## Staff Report

# Spring 2021 Amendment Carroll County Water and Sewer Master Plan

Re: Freedom Water Service Areas

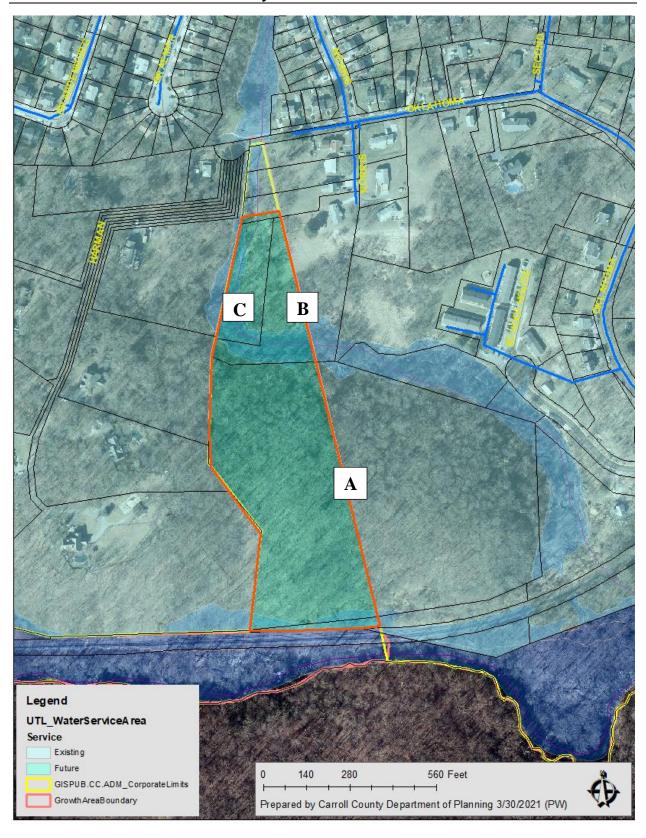
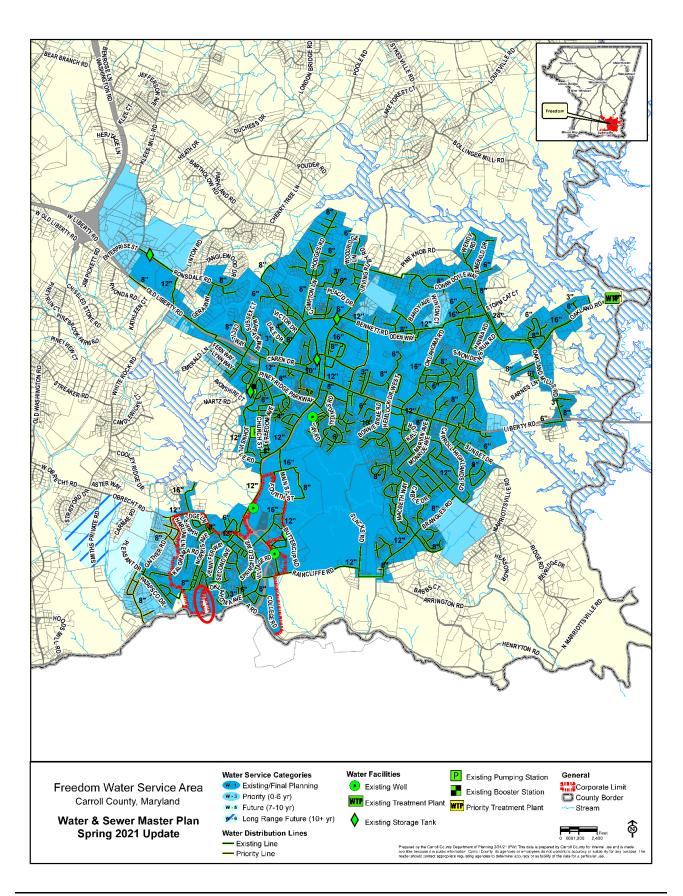
1. Update the Freedom Water Service Area map (12), moving three (A, B, C) properties from Future Service to Priority Service as requested in the submitted application to Annex into the Town of Sykesville.

**Property "A",** Sykesville Development LLC, is zoned Conservation and is split by the Municipal limits. This property has the potential of 5 lots based on BLI, with three of these lots considered in the Existing Service area and the remaining two lots in the Future Service area. **Property "B"** is split by the municipal limits and split zoned. The portion of the property within the Town limits is zoned R-10,000, with the portion in the County zoned Conservation. This property has the potential of 10 new lots based on BLI, all within the Existing Service area. **Property "C"** is in the County and zoned Conservation, being a lot of record, the property is entitled to one residential unit, and is currently in the Future Service area.

Properties "A", "B", and "C" have the potential of 16 new residential units, with the estimated demand totaling 4,000 gpd. Of this demand 3,250 gpd (13 units) is accounted for in Priority Planning as the BLI is based on the portion of the parcels within the Existing Service area. The final 750 gpd (3 units) is accounted for in Future Planning. The request will add the 750 gpd to Priority Planning demand projections.
